CITY PROJECT # 07-24

PALM SPRINGS ANIMAL CARE FACILITY

ADDENDUM NO. 1

Reference Number
Sketch Number
A1-E1

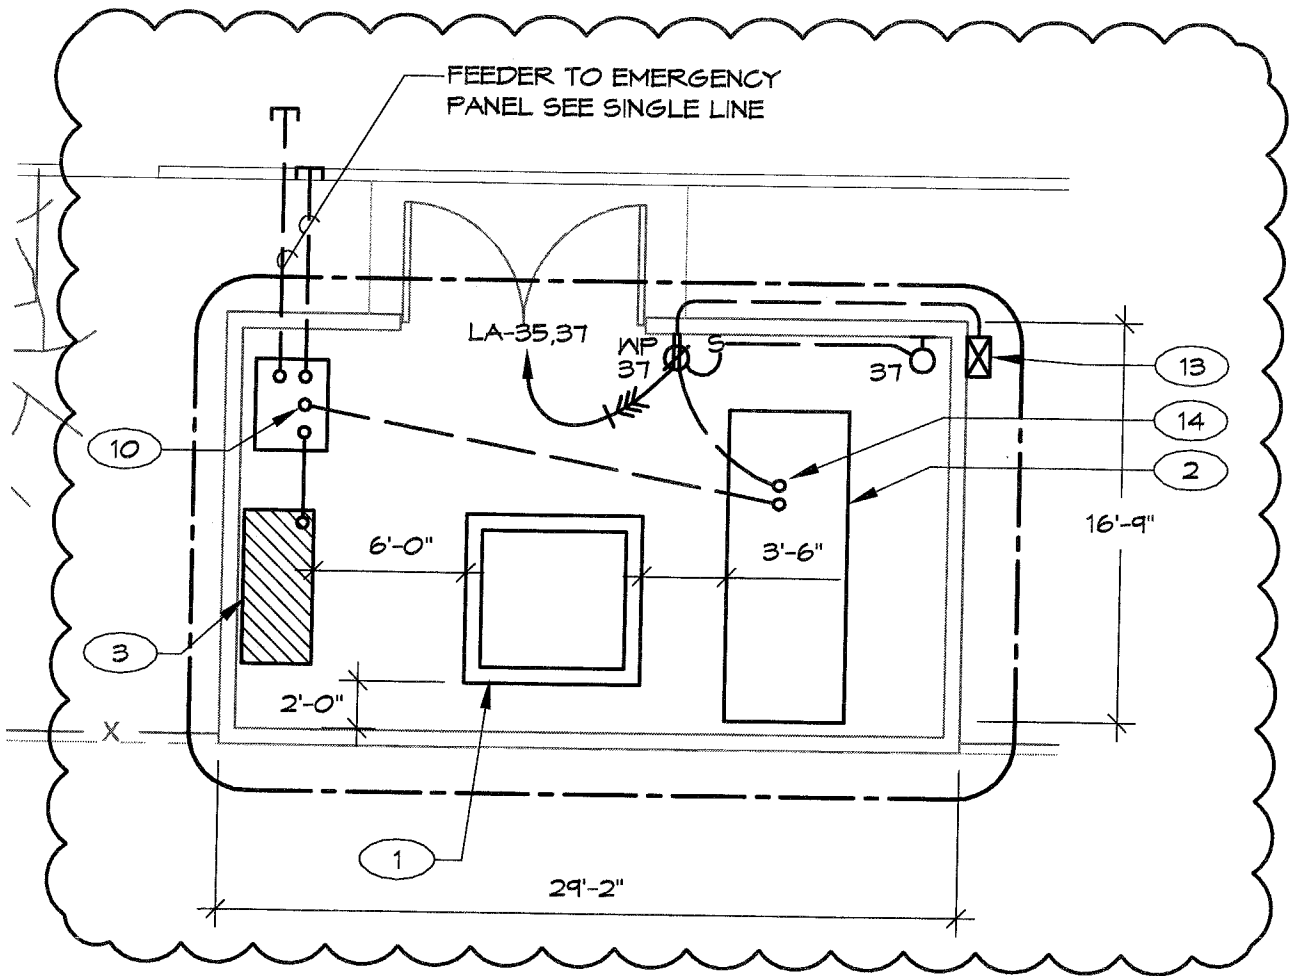
1. **A1-E1:** Revision to Drawing Sheet E1.1 shifting transformer two feet.
2. **A1-E2:** Revision to Drawing Sheet E1.1 shifting two type "T" light fixtures forward.

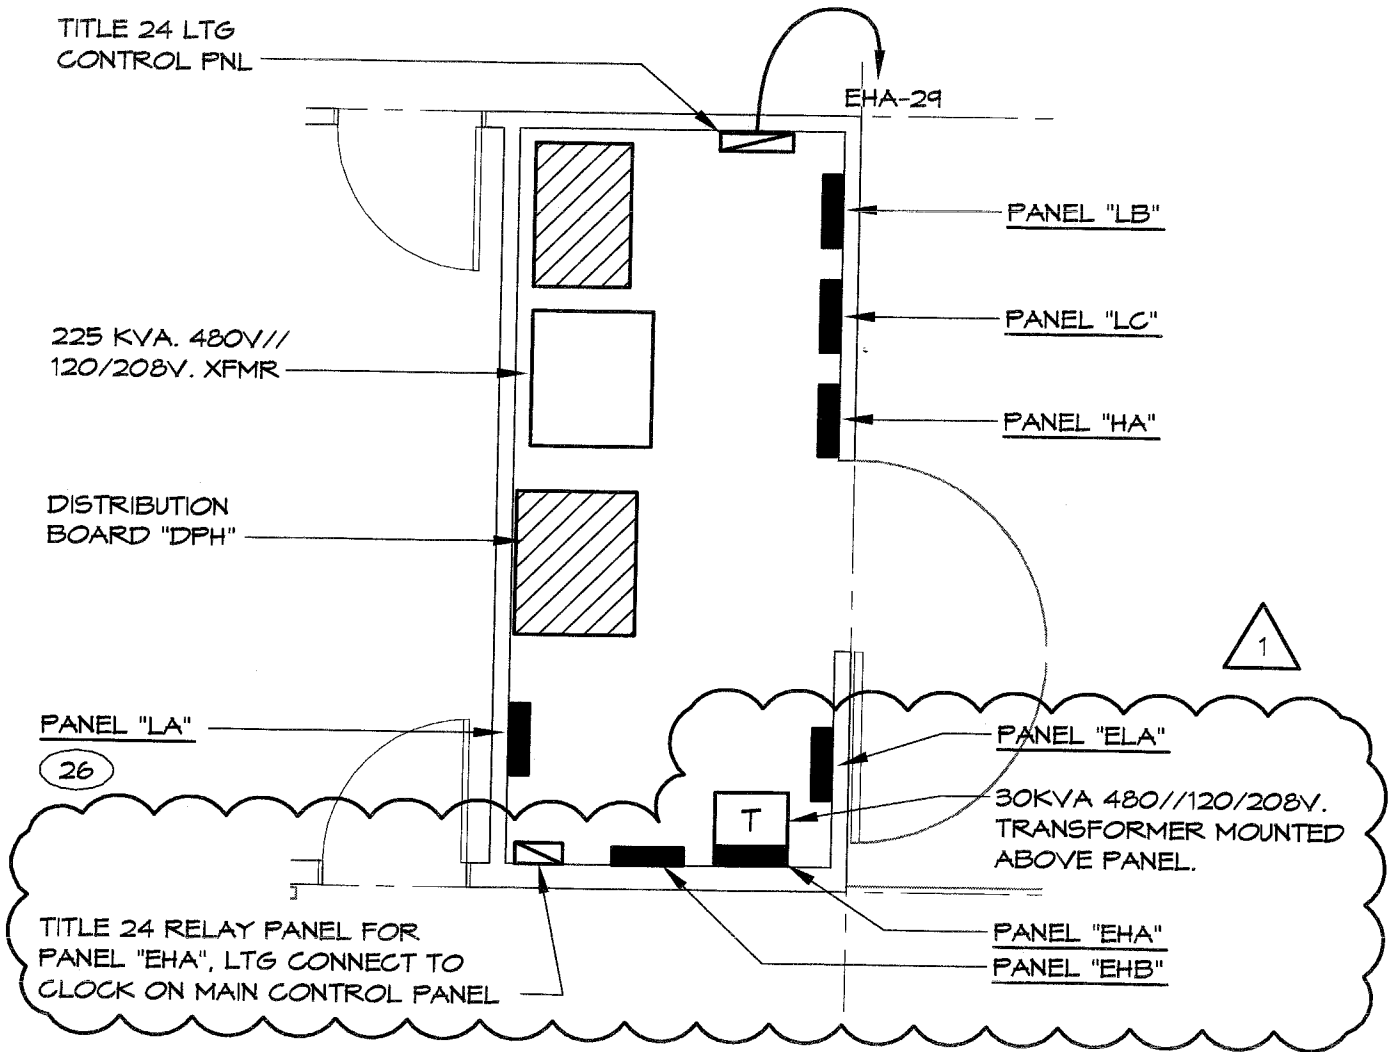
3. **A1-E3:** Revision to Drawing Sheet E3.1 to add callouts for relay panel for emergency circuits.
4. **A1-E4:** Revision to Drawing Sheet E3.2 adding conduit and junction boxes for security system at gates by Dog Wards 4 & 5.

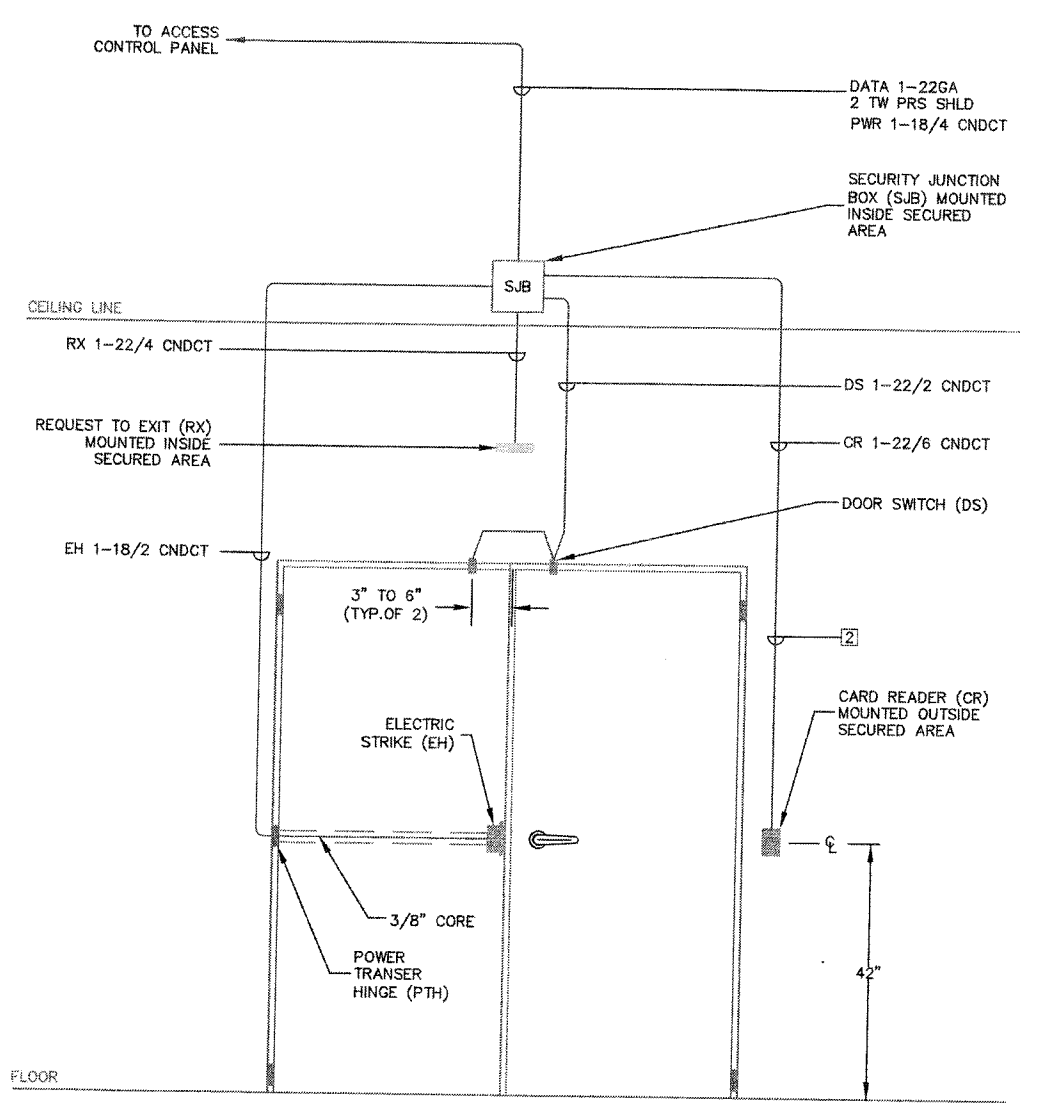
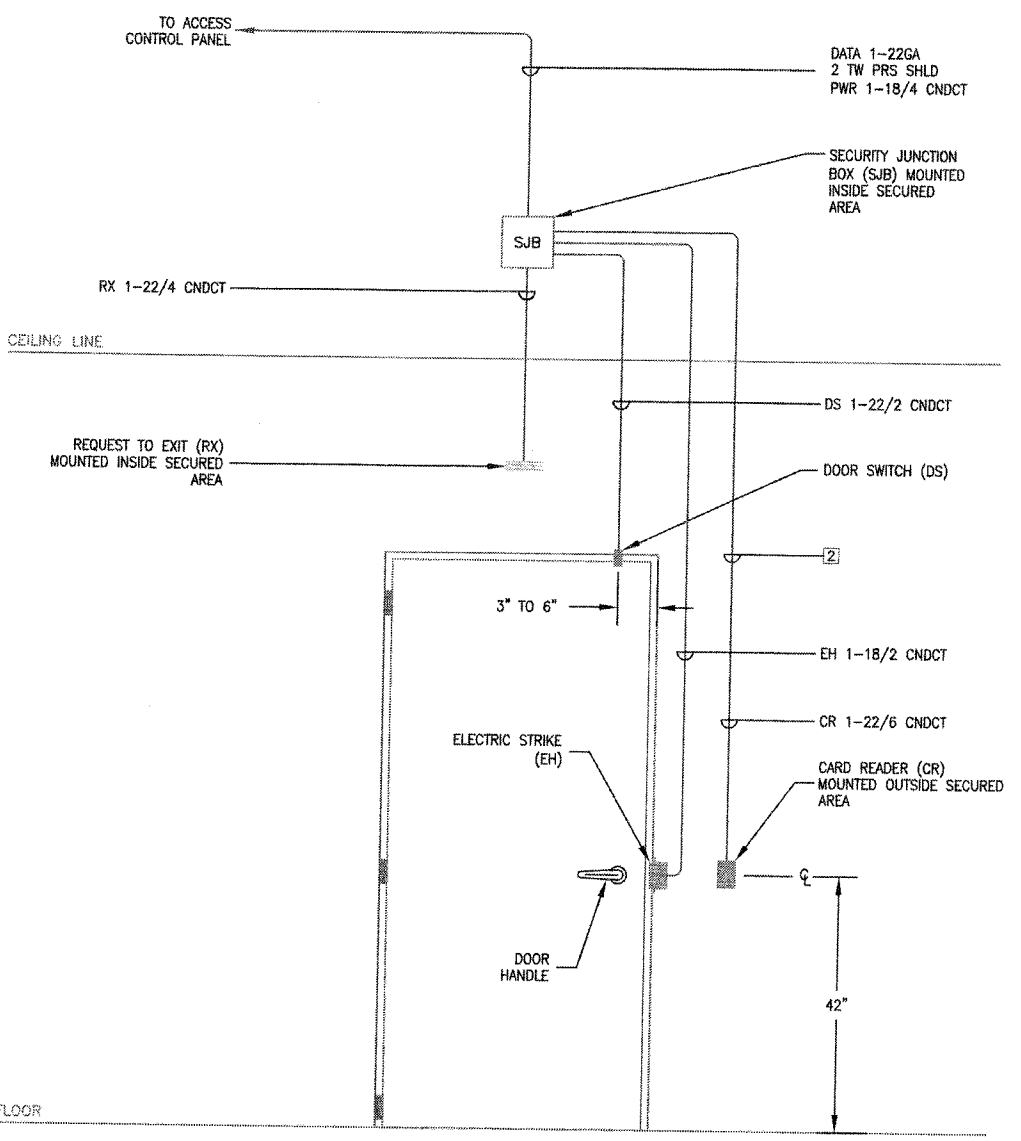
5. **A1-E5 & A1-E6:** Revision to Drawing Sheet E3.2 adding details for clarification of door security conduit and "J" box requirements.
6. **A1-E7 & A1-E8:** Revision to Drawing Sheet E3.3 adding conduit for floor boxes in rooms 108 & 117 to above ceiling.

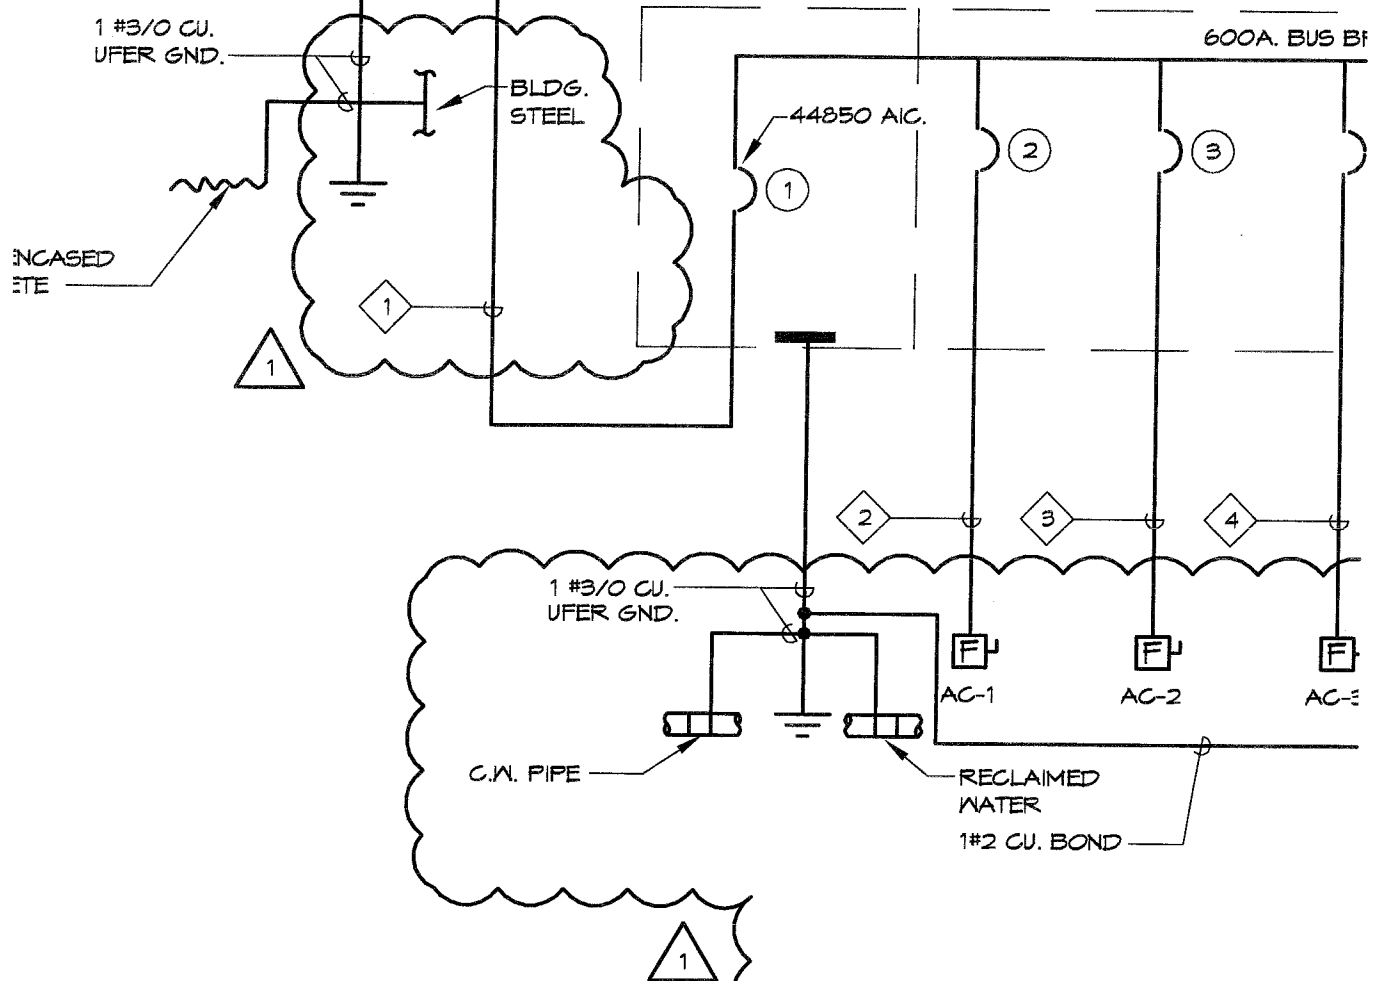
7. **A1-E9:** Revision to Drawing Sheet E5.2 shifting ground callout for reclaimed water from MS to Distribution Panel.
8. **A1-E10:** Revision to Drawing Sheet E5.2 adding bond from DP ground to emergency panels.

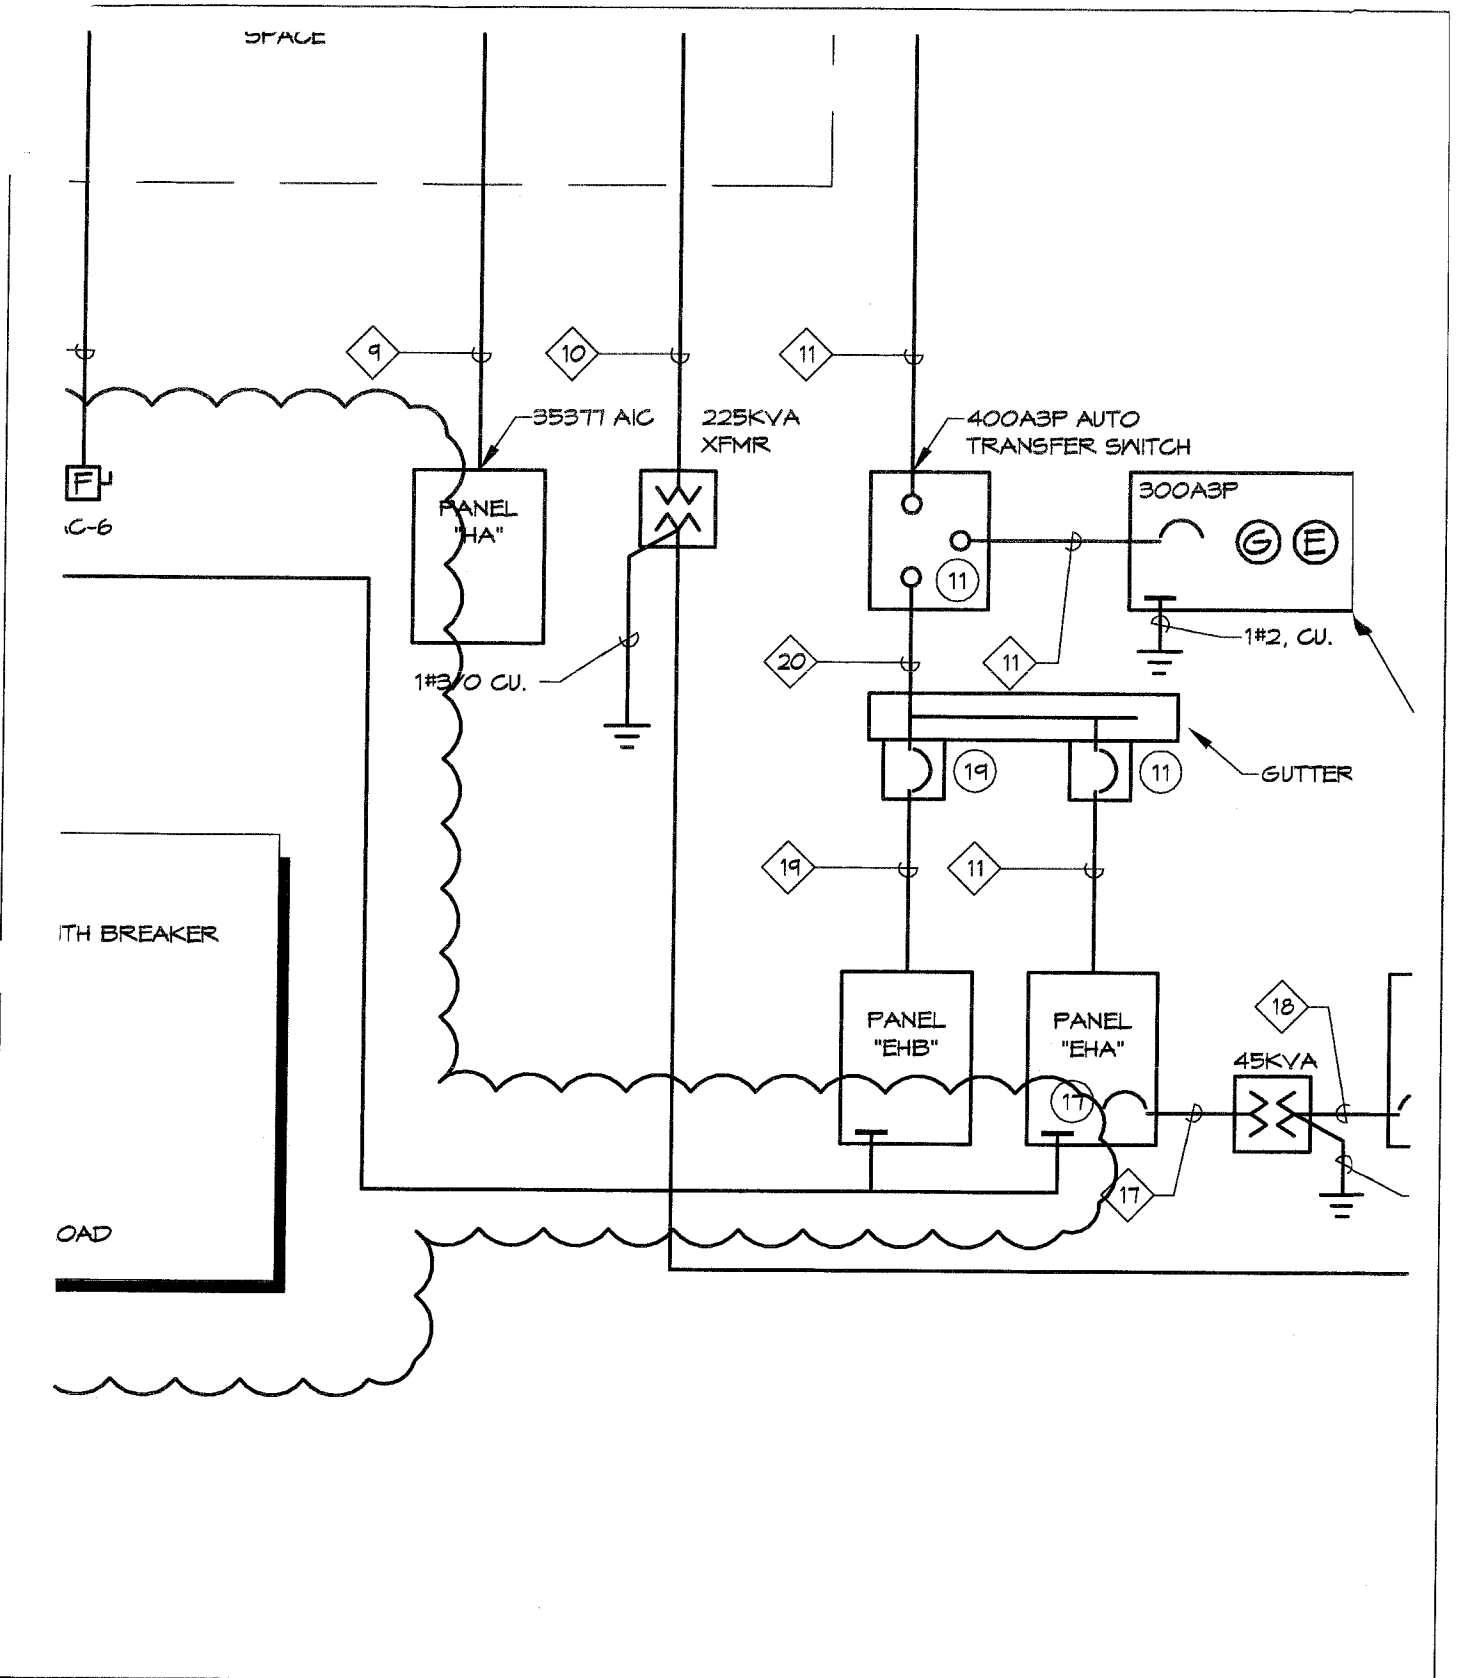
9. **A1-E11:** Revision to Drawing Sheet E5.2 adding note for bonding jumper to structural steel adjacent to Vella Rd.
10. **A1-S1 to A1-S4:** Revision to Drawing Sheet S2B concerning foundations for Planter #1.

1. MANUFACTURER OF SWITCHGEAR IS TO PROVIDE COORDINATED SYSTEM WITH BREAKER TO TRIP IN THE FOLLOWING ORDER
 - 1.1. (17) OPTIONAL STANDBY LOADS
 - 1.2. (11) OPTIONAL STANDBY LOADS
 - 1.3. (19) EMERGENCY LOADS
 - 1.4. (11) GENERATOR FEED
2. PROVIDE BONDING JUMPER TO STRUCTURAL STEEL ADJACENT TO VELLA ROAD
